**PLANNED UNIT DEVELOPMENT
STAFF REPORT****Date: October 6, 2016**

<u>DEVELOPMENT NAME</u>	Checker's Drive-In Restaurant, Inc.
<u>LOCATION</u>	1924, 1965, 2000 & 2222 Dauphin Island Parkway and 1923 Ryders Lane (Northwest corner of Dauphin Island Parkway and Old Military Road, extending to the Northeast corner of Old Military Road and Ryders Lane.)
<u>CITY COUNCIL DISTRICT</u>	District 3
<u>AREA OF PROPERTY</u>	8.7± Acres
<u>CONTEMPLATED USE</u>	Planned Unit Development Approval to amend a previously approved Planned Unit Development to allow shared access and parking on multiple building sites.
<u>TIME SCHEDULE FOR DEVELOPMENT</u>	Not specified.
<u>ENGINEERING COMMENTS</u>	ADD THE FOLLOWING NOTES TO THE PUD SITE PLAN: 1. Any work performed in the existing ROW (right-of-way) such as driveways, sidewalks, utility connections, grading, drainage, irrigation, or landscaping will require a ROW permit from the City of Mobile Engineering Department (208-6070) and must comply with the City of Mobile Right-of-Way Construction and Administration Ordinance (Mobile City Code, Chapter 57, Article VIII). 2. A Land Disturbance Permit application shall be submitted for any proposed land disturbin

SITE PLAN

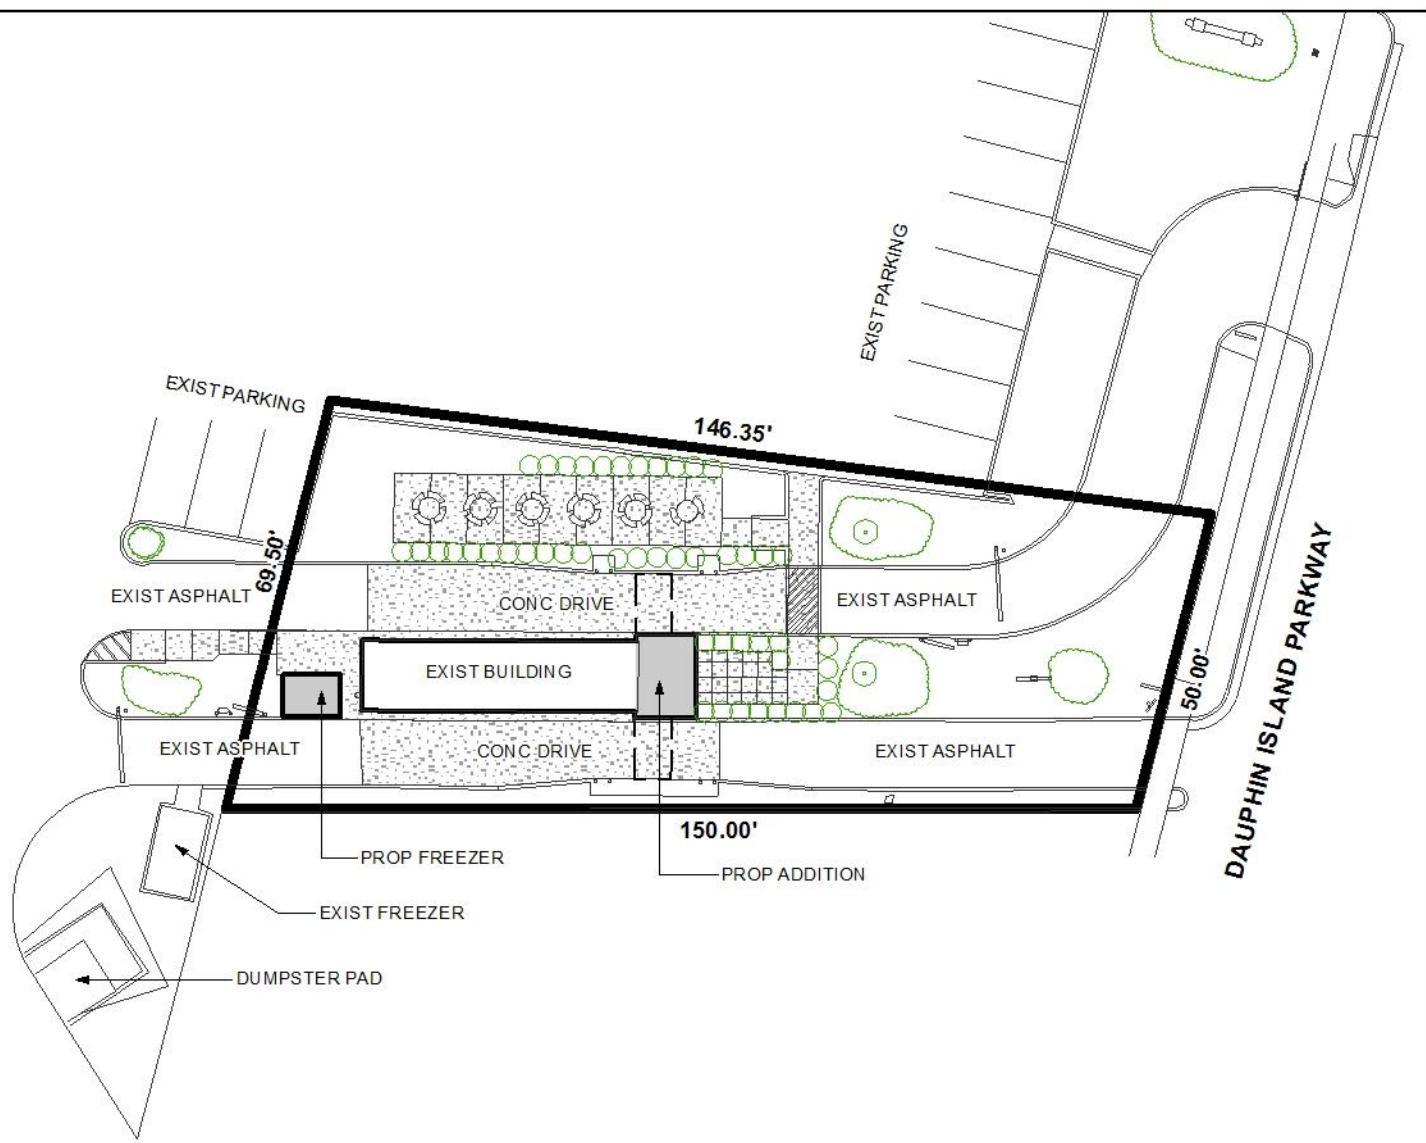
The site plan illustrates an existing 450 square foot building with a proposed 110 square foot addition towards the front of the property to accommodate changing design standards required by Checker's Drive-In Restaurants. Additional changes to the existing site include the replacement of six existing, fixed outdoor tables to the North of the property with six new, fixed outdoor tables in a slightly different configuration, also to the North of the property. The demolition of an existing walkway providing access to an adjacent lot north of the property is proposed, with a new walkway to be installed east of the original walkway. The new walkway will provide ADA access to the proposed, fixed outdoor seating via a concrete ramp.

Queuing spaces for the northernmost drive-thru lane comply with requirements of Section 64-4.F.2. of the Zoning Ordinance regarding vehicle stacking; however, it does not appear that the southernmost drive-thru lane complies with such regulations, with its entrance to the ordering station and menu board being situated on a separate lot to the West of the site. Previous Planned Unit Development approval allowed such shared access, thus facilitating compliance with drive-thru design standards regarding drive-thru businesses integrated in a shopping center. However, it is unclear if variations in the placement of ordering stations, clearance bars, etc., will impact existing shared drive-thru configuration with respect to the lot to which the site in question has access since site plans for the entire development were not provided. Nevertheless, the applicant does not propose to make changes to existing drive-thru lanes, and changes in the placement of ordering stations and clearance bars are minimal. Therefore, given the site's lengthy existence and its previous Planned Unit Development review and approval, vehicle stacking on the subject site may be in compliance.

Parking is not illustrated on the site plan, therefore Staff cannot determine if the site complies with parking requirements as they are impacted by the proposed addition to the existing building;

Landscaping is proposed on the site, but not for the overall development; and information regarding landscaping is not depicted with regards to the calculations needed to ensure compliance. While no significant structural enhancements to the site are proposed that would necessitate full compliance with tree and landscaping requirements of the Zoning Ordinance, all existing and proposed landscaping and tree plantings for the entire development need to be illustrated, along with their calculations, on a revised site plan.

A dumpster enclosure is illustrated on the site plan, but is not located on the lot whereon Checker's Drive-In Restaurant is situated; and it is unclear if the existing dumpster meets enclosure and sanitary sewer requirements of Section 64-4.D.9. of the Zoning Ordinance. Again, previous Planned Unit Development approval allows shared access between the subject site and the lot on which the aforementioned dumpster is located, therefore the dumpster may be in compliance; nevertheless, it should be noted that if the subject site chooses to utilize their own dumpster, a revised site plan should illustrate its compliance with Section 64-4.D.9., or a note placed on the site plan stating curb-side pick-up will be utilized should be required.

A sidewalk is located along the frontage(s) of the subject site, but it is not clearly illustrated on the site plan. A revised site plan should clearly indicate existing sidewalks to ensure compliance with the Zoning Ordinance.

RECOMMENDATION Based on the preceding, the request is recommended for Holdover to the November 3, 2016 meeting, with revisions submitted by October 20, 2016, to allow the applicant to address the following:

- 1) submit a full site plan illustrating all existing and proposed site improvements to the entire Planned Unit Development.
